Transport
Canada

Amendment 002

Subject: Request for Bid No. T5000-190002
Office Furniture – Categories 1, 2 and 3

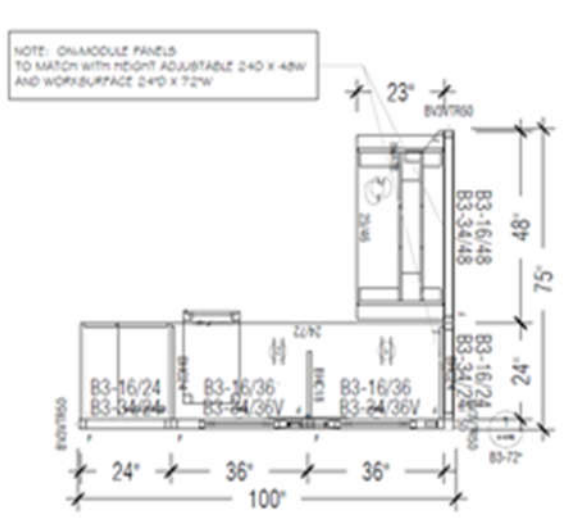
2. Is a height adjustable shelf required in the wardrobe section?

Answer: no shelf is required in wardrobe section but must have bar for coat hanger(s). Also, must have door with keyed lock.

Open storage requires two height adjustable shelves.
